GRID CURRENT BALANCE CIRCUITRY
REMOVED AND INPUT SELECTOR
SWITCHES CHANGED TO REDUCE INPUT
HOOK AND TRACE SHIFT RESPECTIVELY

M9709

Type 10A1 Plug-in Unit

FIG. 1

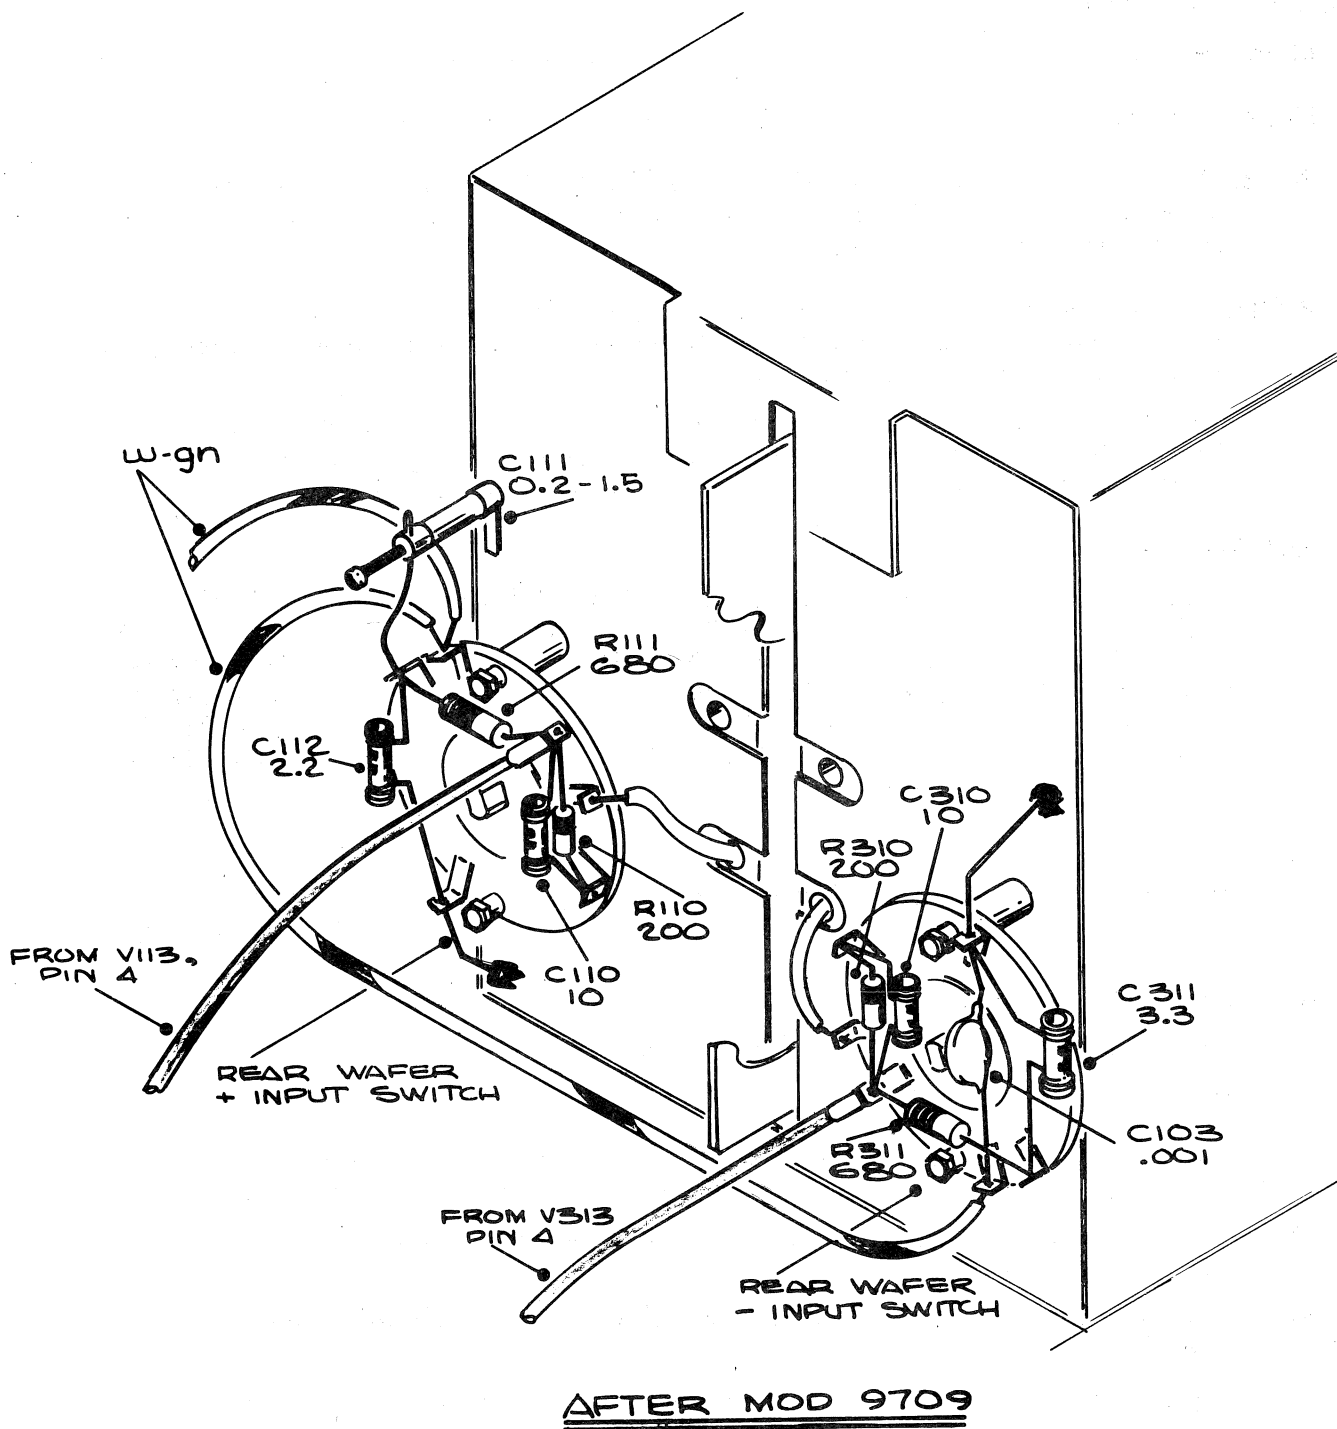
NOTE: In the following procedure, it is only necessary to replace the rear wafers of the + and - INPUT switches. Also, refer to Figs. 1 and 2 for component locations.

- Remove the white-brown wire from terminal 10 of the +INPUT switch and cut it flush with the cable harness.
- Remove the white-green wire from terminal 4 of the -INPUT switch and cut it flush with the cable harness.
- Replace the rear + and - INPUT switch wafers and wire components as shown in Fig. 1.
- Replace R105C, R106G, R305C and R306G with #22 bare wire straps as shown in Fig. 2.
- Remove R137 (100 k 1/4W 5%) located between forward terminals of the -Grid Current Bal pot (R336) and Int DC Bal pot (R200).
- Remove the white-brown and white-green wires connected to the Grid Current Bal pots and cut them flush with the cable harness.
- Remove the - and + Grid Current Bal pots, R136 and R336, and their hardware from the main chassis.

BEFORE MOD 9709

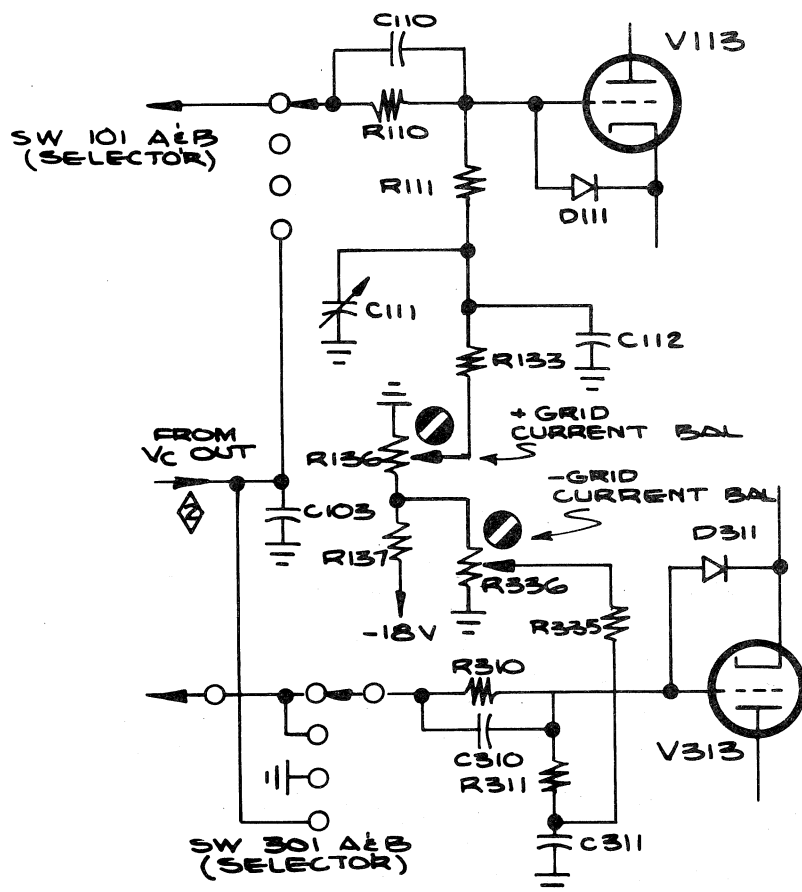
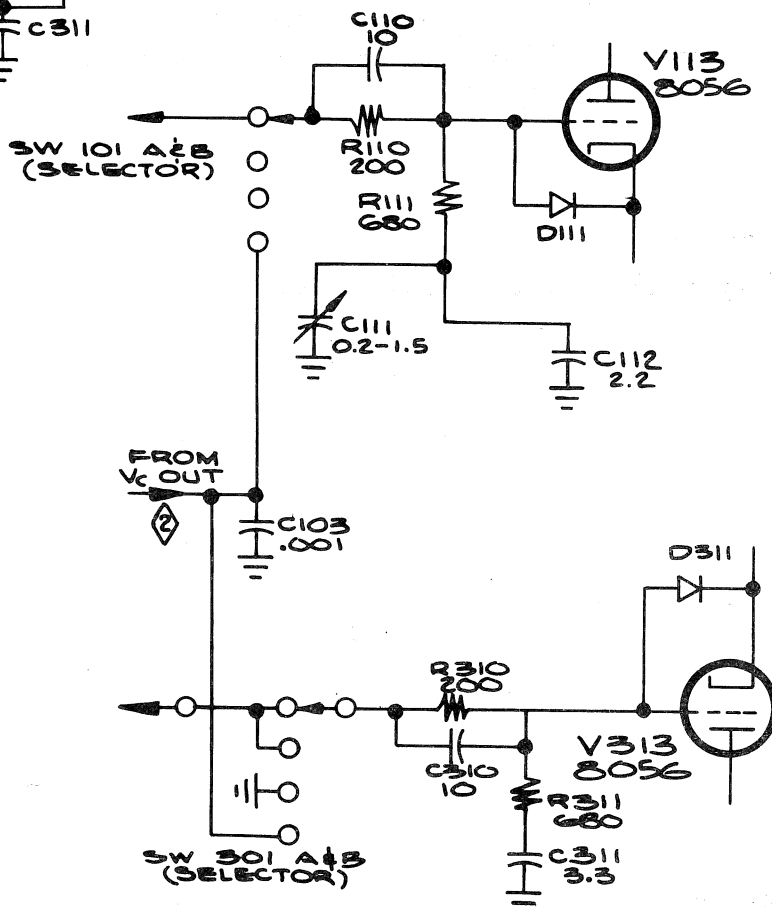
PROBLEM: The hook is caused primarily by the 100 Meg Grid Current Bal potentiometer isolation resistors, R135 and R335. The Grid Current Bal pots are not needed since grid current is not a problem.

PRODUCTION CHANGE: The Grid Current Bal pots and associated components were removed as indicated in the Before and After schematics on a following page. Typical grid current without pots is about 0.2 nA.

After the Grid Current Bal circuitry was removed, it became necessary to replace the + and - INPUT switches with a make-before-brake type, to eliminate any trace shift which would occur with the absence of the Grid Current circuitry.

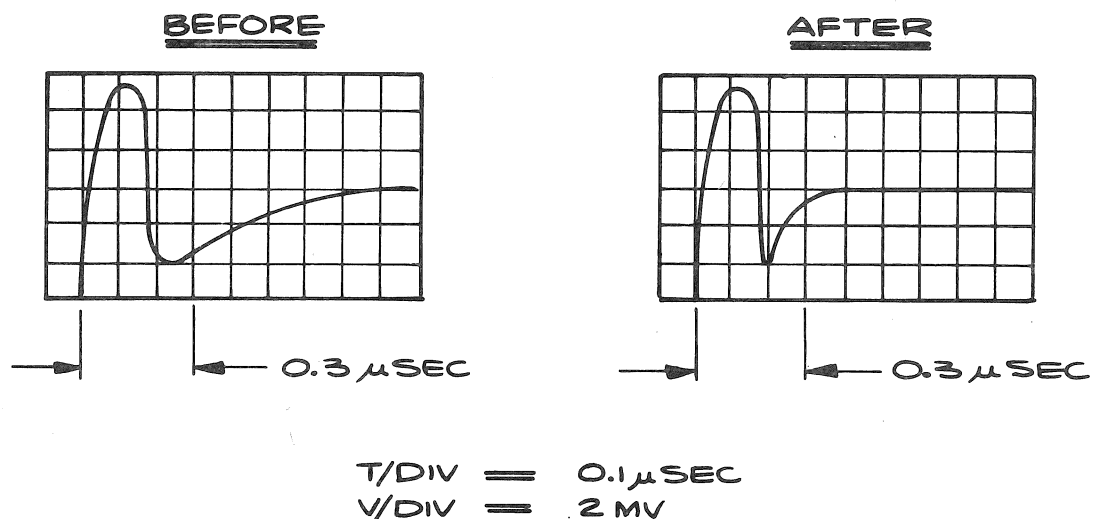
PROBLEM: Test found it necessary to select Q153 and Q353 to meet the overload recovery test limit. The recovery time after differential offset must be less than $0.3\mu\text{s}$ for a return to within $\pm 2\text{mV}$.

PRODUCTION CHANGE: The 151-0134-00 PNP transistors, located at sockets Q153 and Q353, were changed to 151-0199-00 type transistors.

Replace Q153 and Q353 with 151-0199-00 transistors.

NOTE: If Q153 is replaced, then Q353 must also be replaced and vice versa.

INPUT AMPLIFIER 10A1 (PARTIAL)

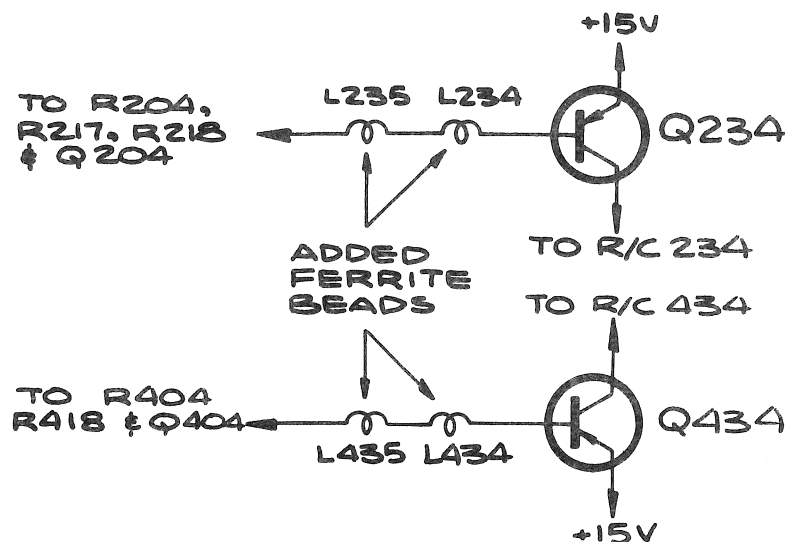
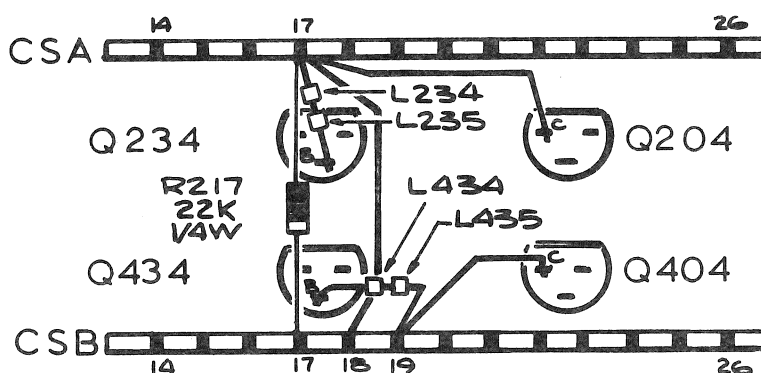
PROBLEM: 20 MHz oscillation in operational amplifiers Q204, Q404, Q234 and Q434.

PRODUCTION CHANGE: Ferramic suppressors (L234, L235), (L434 and L435) were added to the base leads of transistors Q234 and Q434 respectively. The circuit layout of input amplifier transistors Q204, Q234, Q404 and Q434 was changed to eliminate the 200 MHz oscillation. Also see M10995 for the Type 11B1 and RM647.

Installation Procedure: Refer to drawing for steps (a) through (i).

- a) Remove R217 (22k 1/4 W 5%) between base pin of Q234 and CSB-17.
- b) Replace the #22 bare wire between base pin of Q234 and collector pin of Q204 with a new wire, between CSA-17 and collector pin of Q204.
- c) Replace the #22 bare wire, between collector pin Q404 and base pin Q434, with a new wire, between collector pin Q404 and CSB-19.
- d) Remove the #22 bare wire, between base pin of Q234 and CSB-18.
- e) Solder a #22 bare wire to base pin of Q234. Add ferramic cores L234 and L235 to the wire, soldering the free end to CSA-17.

- f) Unsolder the CSB-19 end of a #22 bare wire connected to the base pin of Q434.
- g) Add ferramic cores L434 and L435 on the unsoldered wire (step f). Resolder the wire to CSB-19.
- h) Add a #22 bare wire, between CSA-17 and CSB-18.
- i) Add a new 22k 1/4 W 5% resistor (R217), between CSA-17 and CSB-17.
- k) Add a 1/4" solder lug between flat washer and top of chassis on potentiometer R215 (Var Atten Bal) position toward front of plug-in and tighten nut.
- l) Solder a #22 bare wire, between solder lug in near by metal shield on the VOLTS/CM AND V_c RANGE switch SW710.

FIGURE 4-1

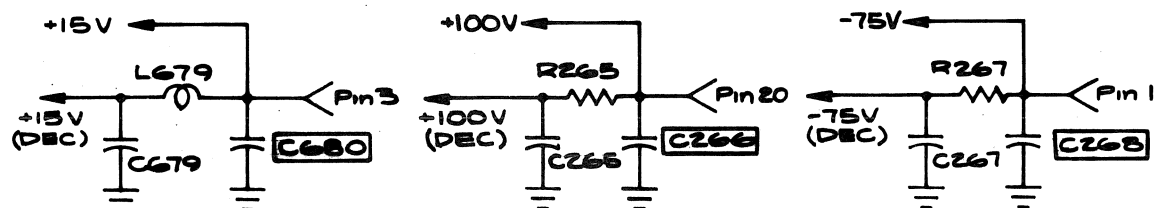
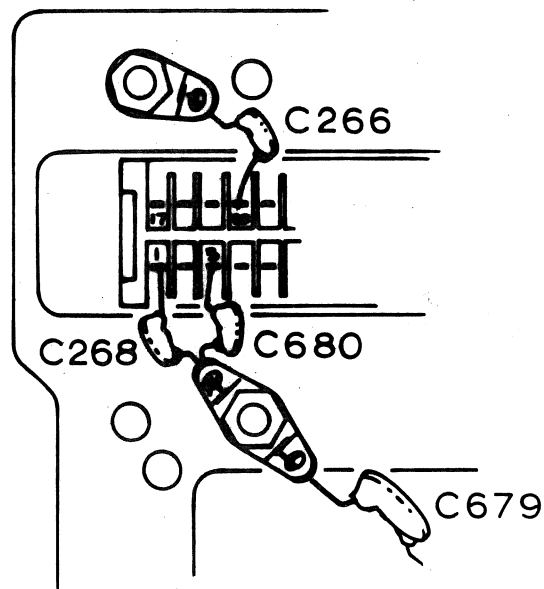
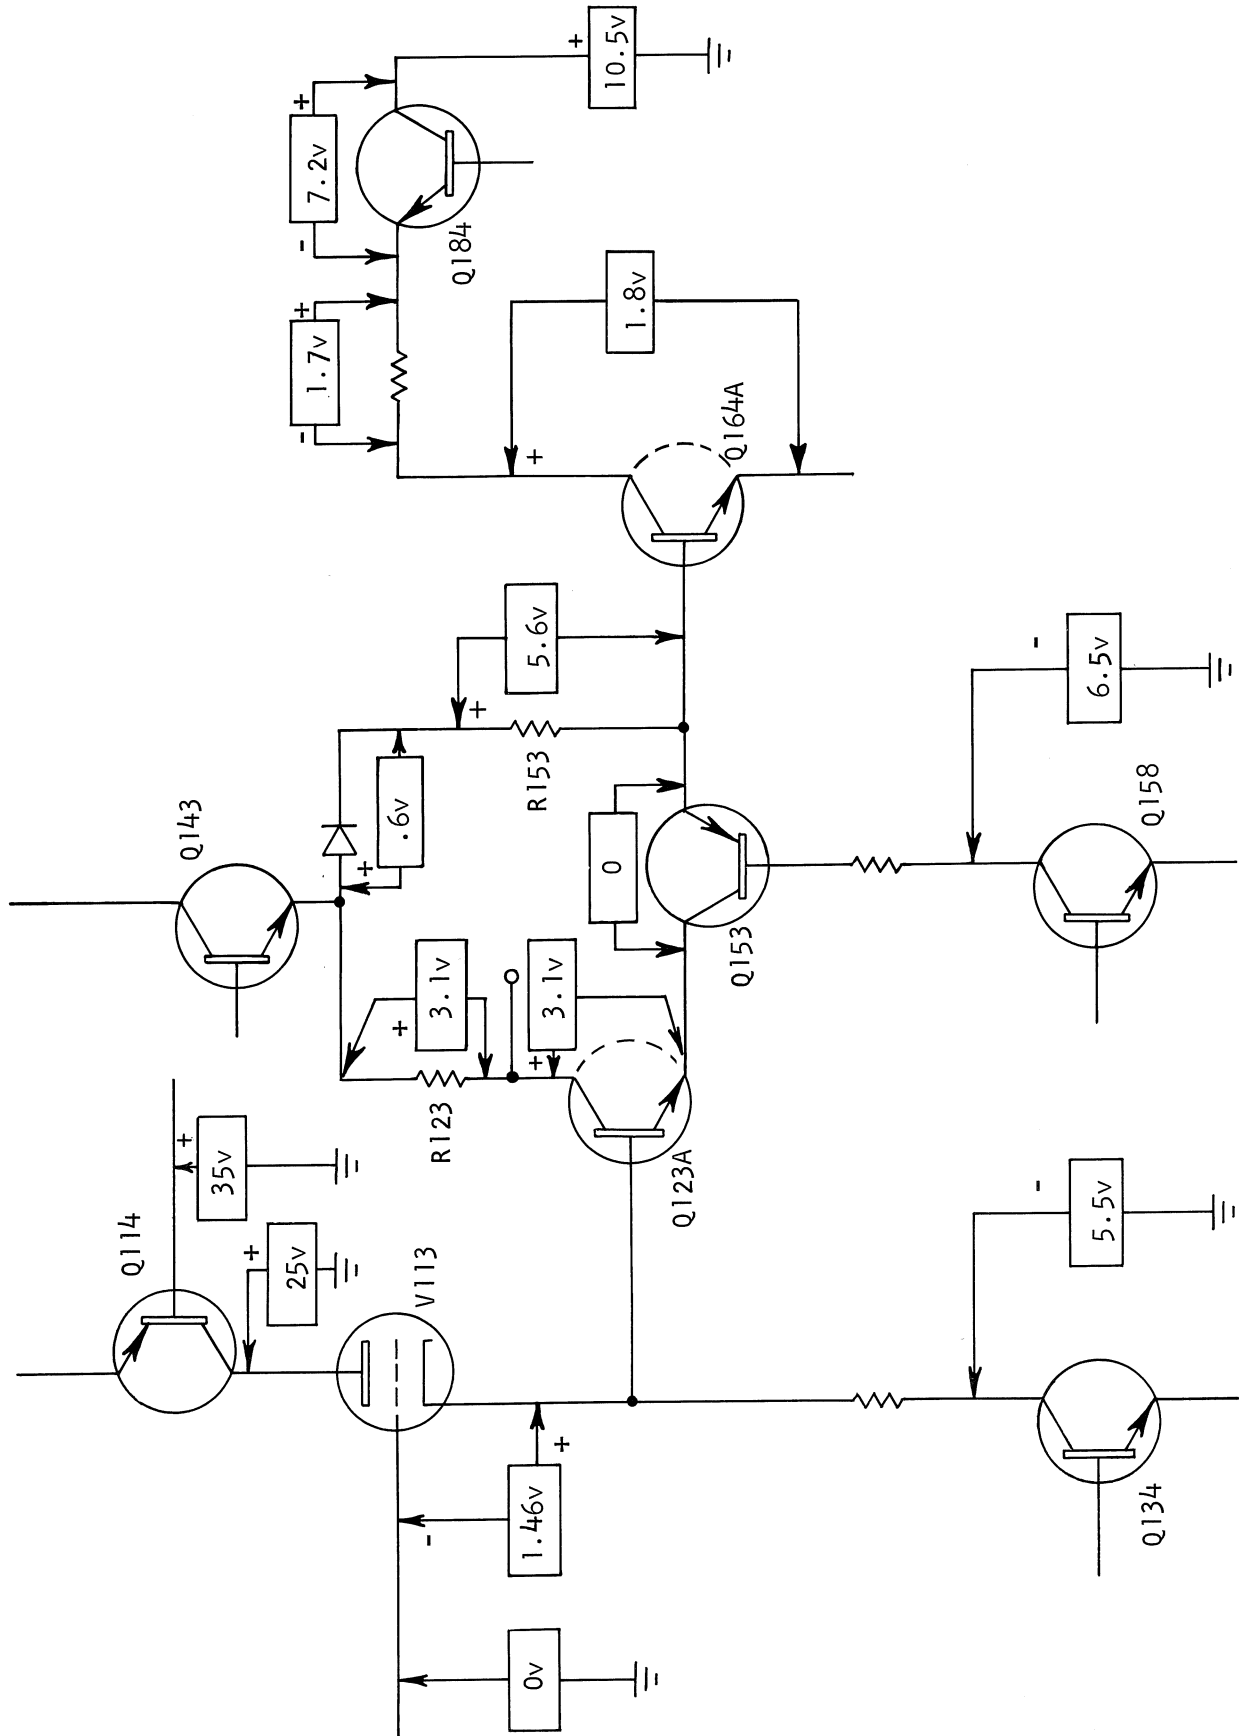
Additional power supply decoupling is provided by this modification to reduce the amount of sweep start transients being coupled into the vertical circuitry. These transients can cause objectionable vertical aberrations to appear on the trace, particularly at 1 mV/CM vertical sensitivity and fast sweep speeds.

The additional decoupling is provided in the +100V, -75V, and +15V supplies.

- 1) Unsolder the lead of C679 going to ground solder lug near pin 1 of the amphenol connector.
- 2) Remove the ground solder lug and relocate it near pin 17 of the amphenol connector, as shown in the illustration.
- 3) Install a double-end ground solder lug (210-0204-00) in the location shown in the illustration, using a 6-32 x 1/4 PHS screw and a 6-32 x 5/16 Keps nut.
- 4) Install C266, C268, C680, and the lead of C679 removed in step 1, as indicated in the illustration.
